**FINAL DRAINAGE REPORT
FOR
STERLING RANCH FILING NO. 2**

**September 2020
Project No. 25188.01**

Engineering Review

PCD File No. SF-20-015

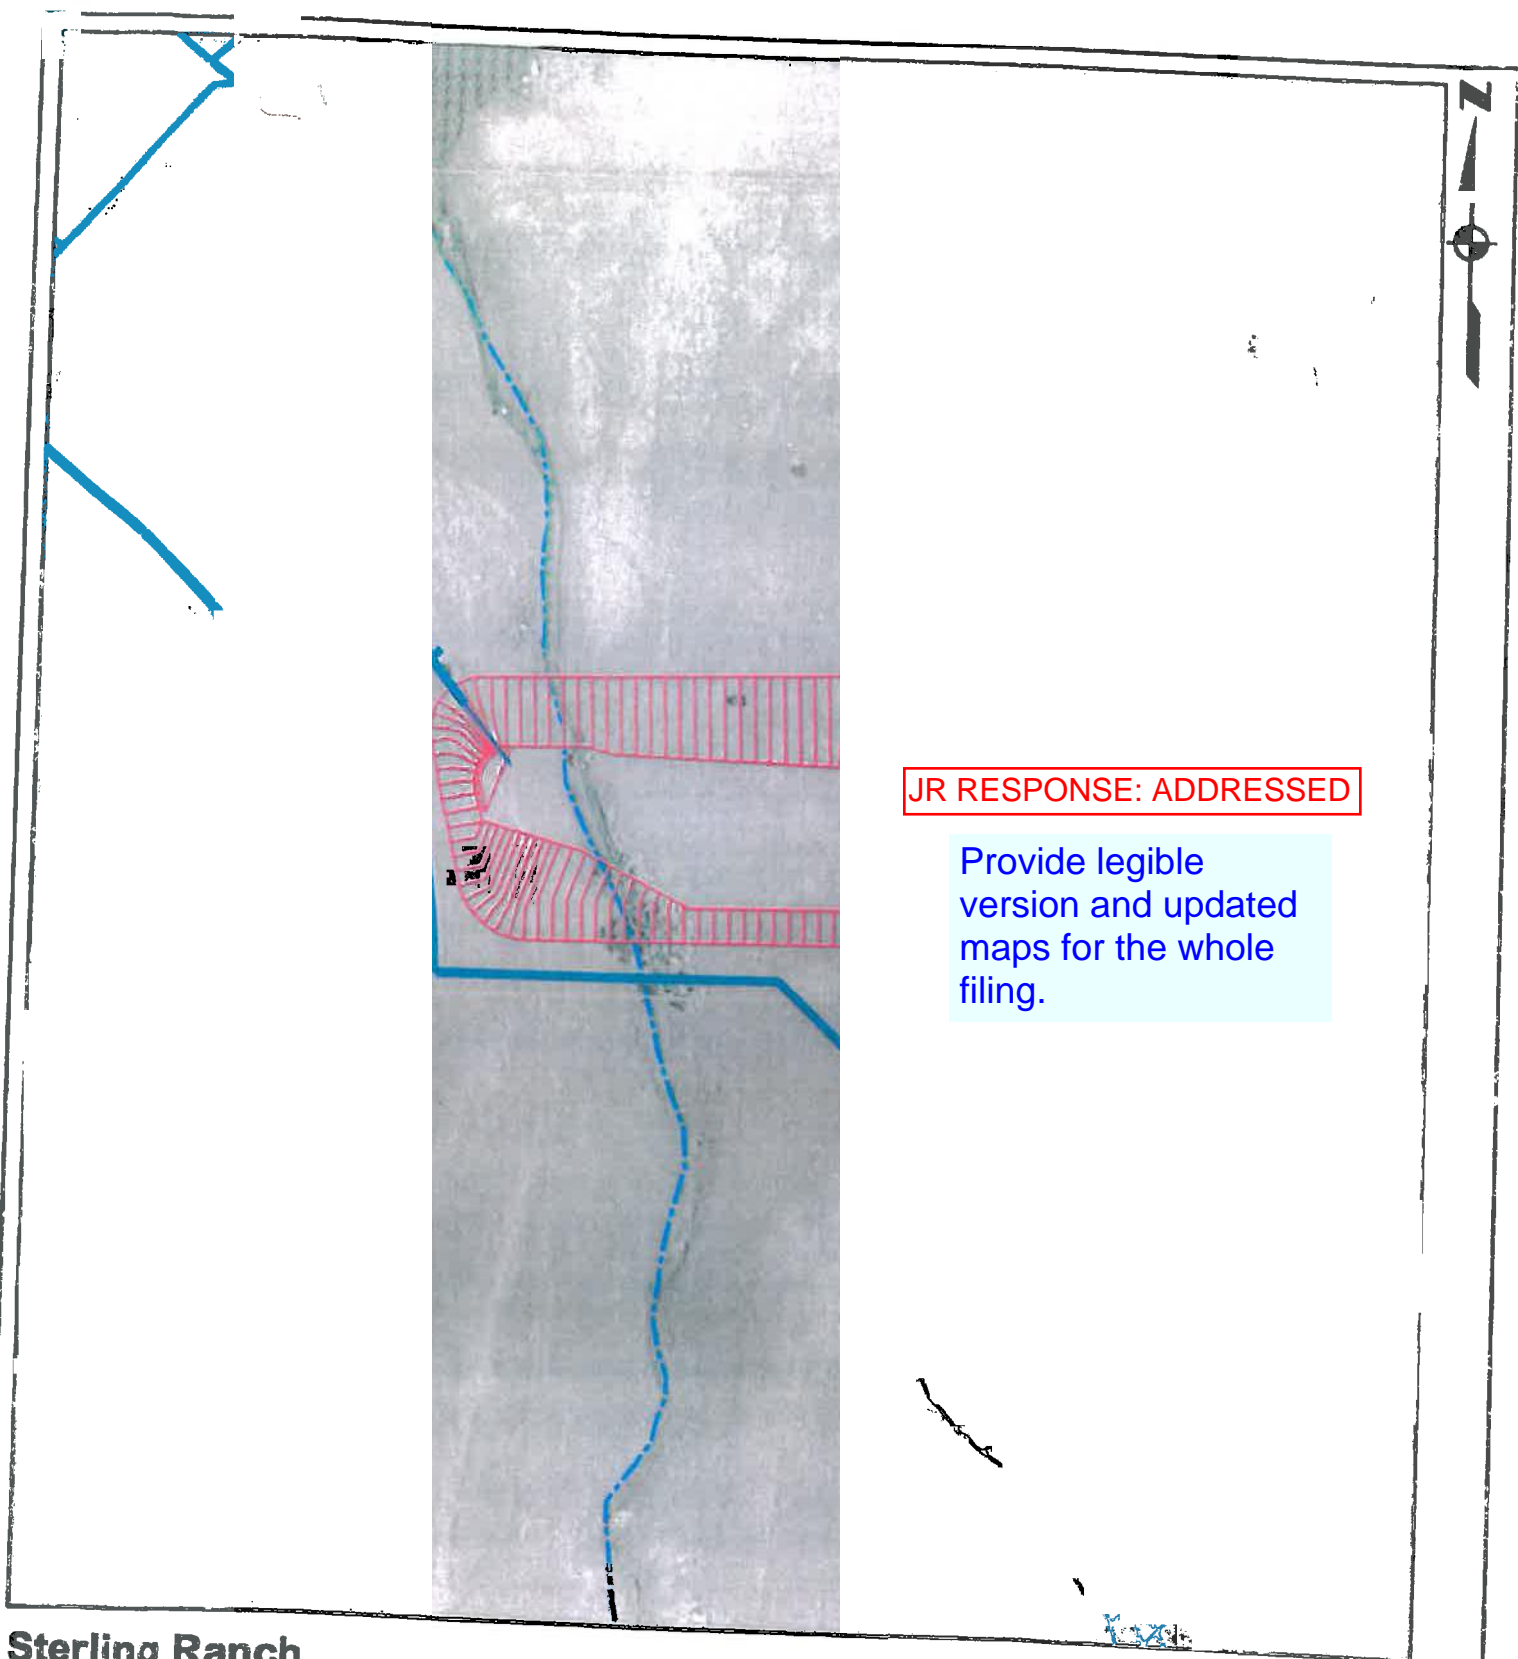
Provide legible version and updated maps for the whole filing.

JR RESPONSE: ADDRESSED

DETENTION BASIN OUTLET STRUCTURE DESIGN

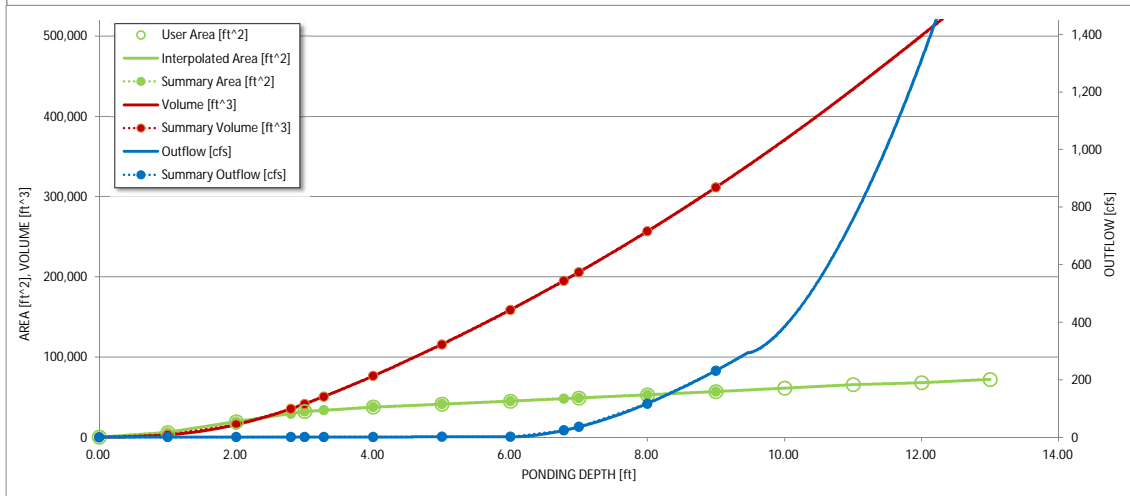
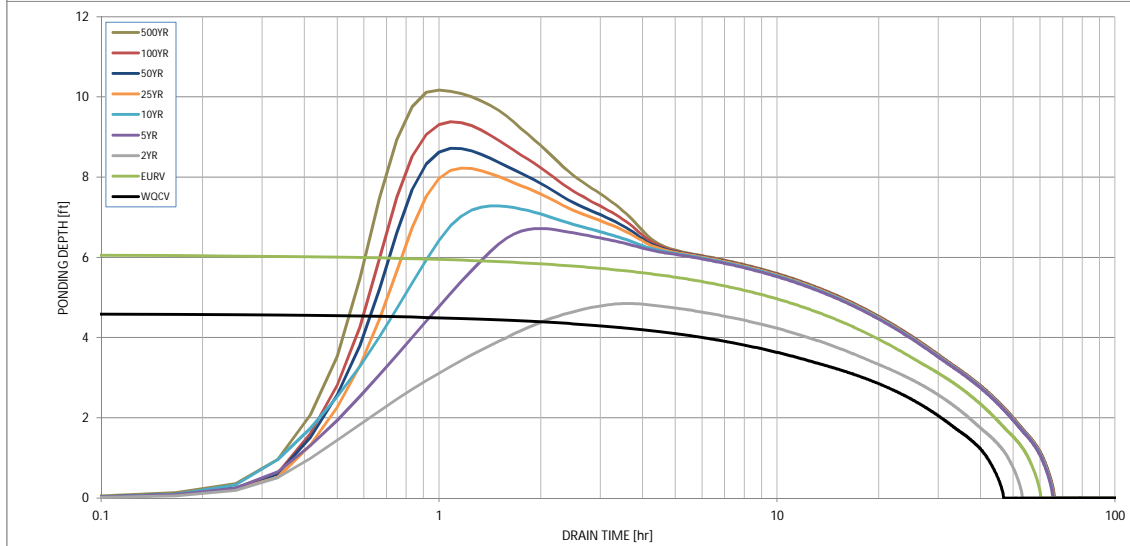
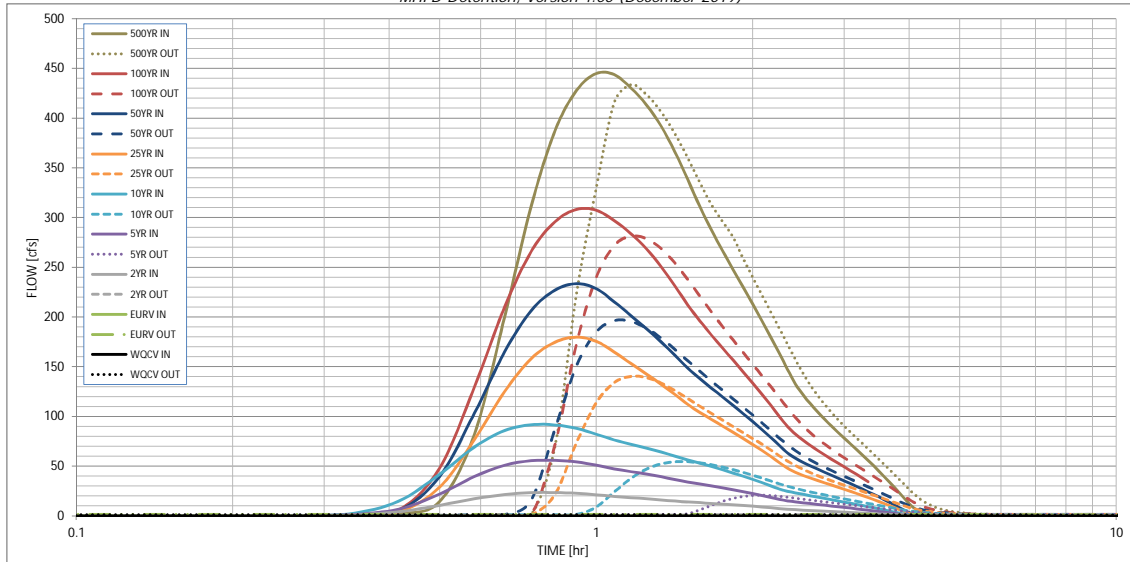
Verify grate size

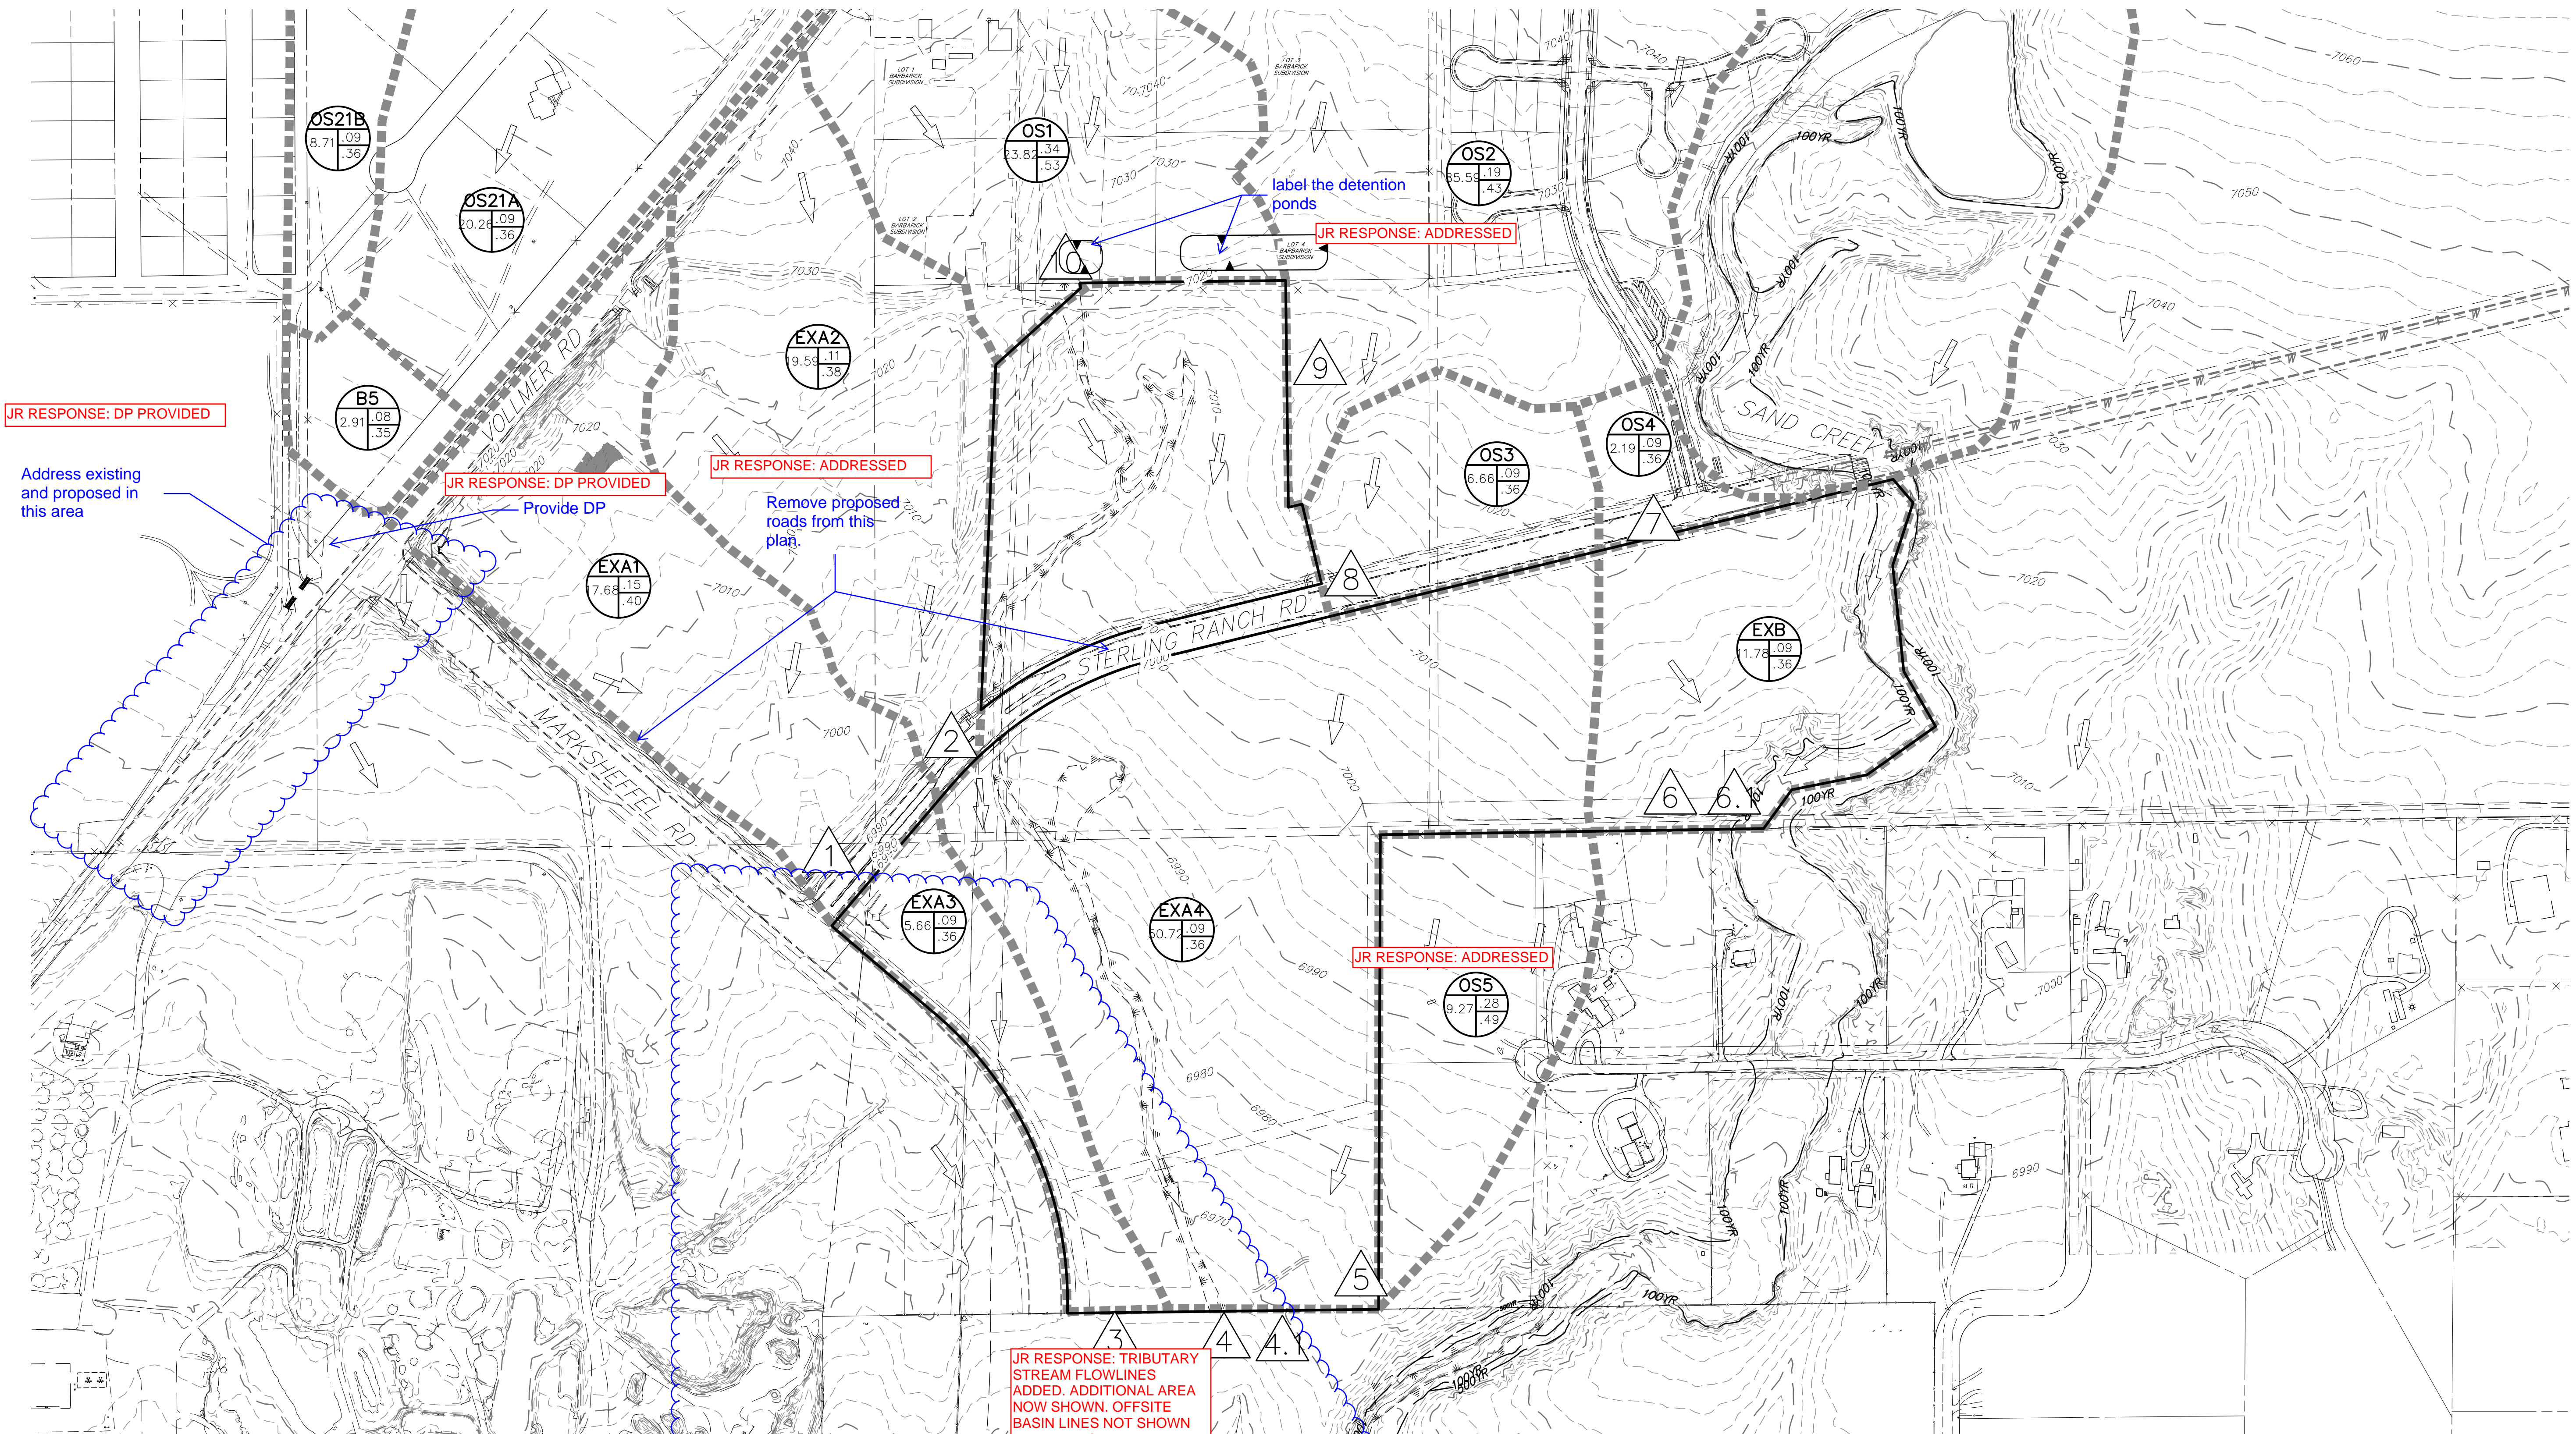
See plat
comments for
added tracts
